ENGINE - IGNITION - INTRODUCE IGNITER PLUG INSERTS WITH AN INCREASED WALL THICKNESS AND  
IMPROVED THREAD REQUIREMENTS - CATEGORY CODE 4 - MOD.ENG-74-0004

V2500-ENG-74-0004

Location of the Screw Thread Insert (V2500-A1, V2522-A5, V2524-A5, V2527-A5 and V2530-A5)  
Fig.1

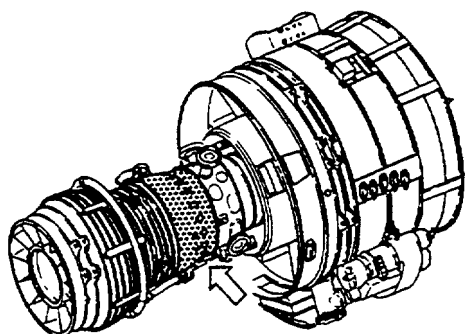
(1) Replace the Screw Thread Inserts that are used with the Igniter Plug.

Modification of the Screw Thread Insert (V2500-A1 and V2528-D5)  
Fig.2

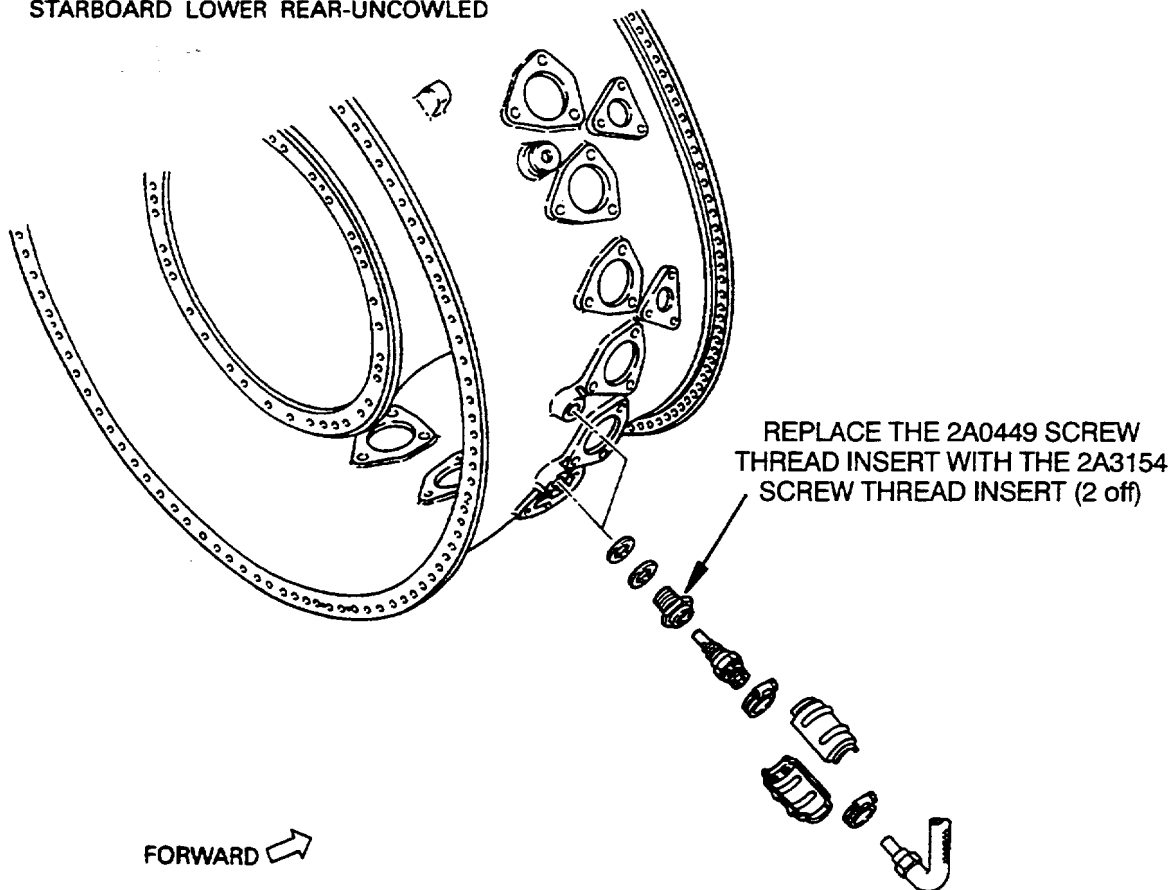
A thin wall condition is possible in some igniter plug inserts. This reduced thickness results in reduced part strength and can lead to complete fracture, particularly during igniter removal.

Replace the inserts with the potential thin wall condition with a new insert that has increased wall thickness, eliminating the potential for fracture.

2A3154 (74-21-41)	2	244.00	Insert, Screw Thread	2A0449 (01-020)	(S1)(A)(B)
----------------------	---	--------	-------------------------	--------------------	------------

Checking Igniter Plug Immersion Depth (V2500-A1, V2522-A5, V2524-A5, V2527-A5, V2530-A5, V2525-D5 and V2530-D5)

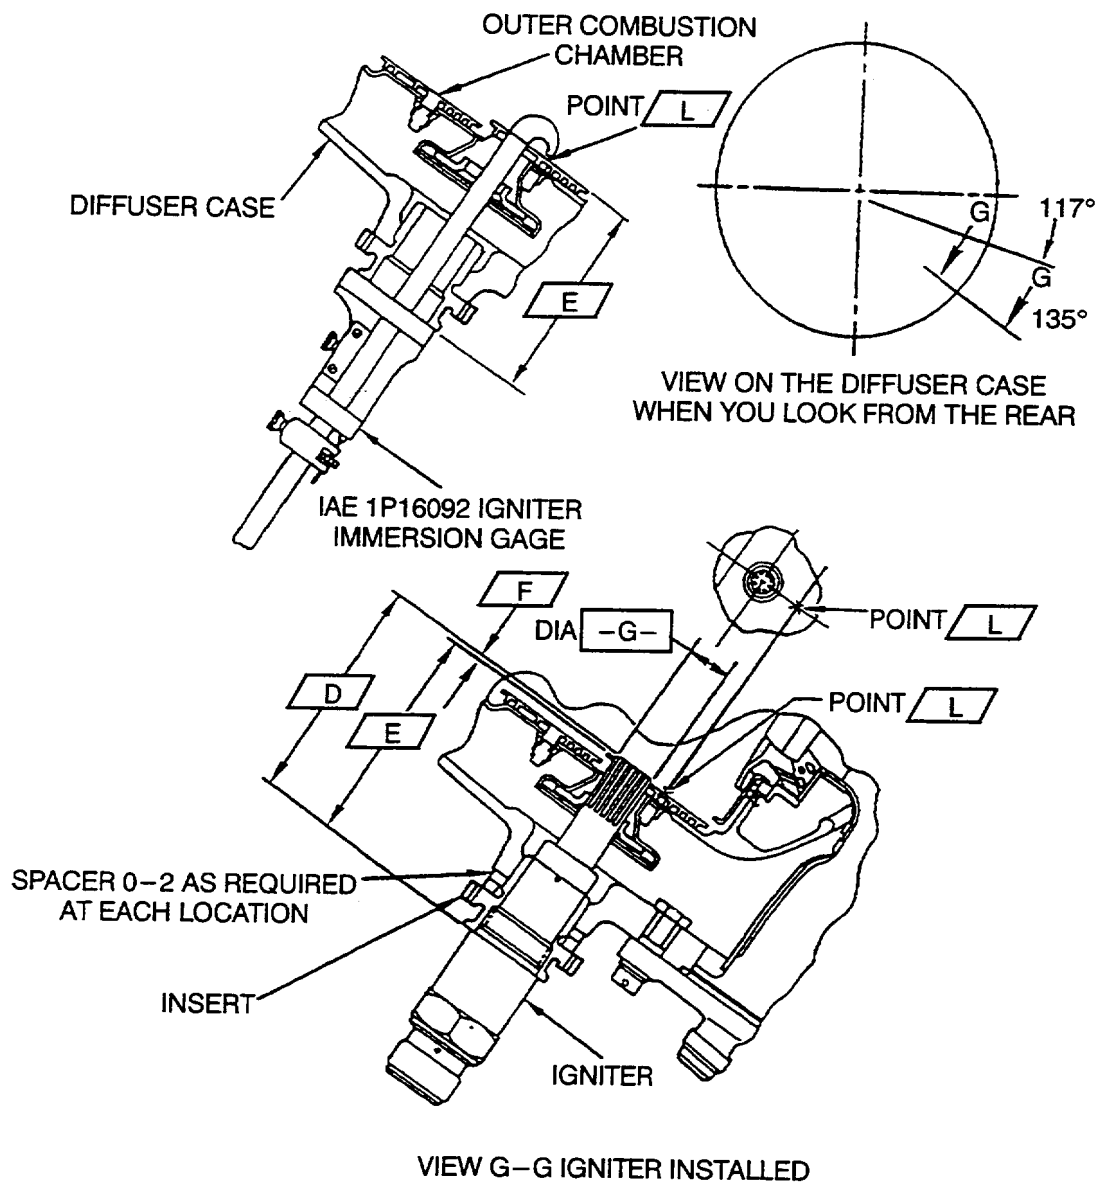
E. Do a check of the igniter plug immersion depth. See Figure 3.

(1) Measure the distance E from the top of the insert to the point L on the outer combustion chamber nearest the fuel nozzle. Use the IAE 1P16092 Igniter Immersion Gage (1 off).

(2) Measure distance D from the surface of the igniter plug that touches the threaded insert to the inner end of the igniter plug.

(3) The difference between distance E and distance D is the igniter immersion depth F which must be 0.040 to 0.80 inches (1,02 to 2,03 mm).
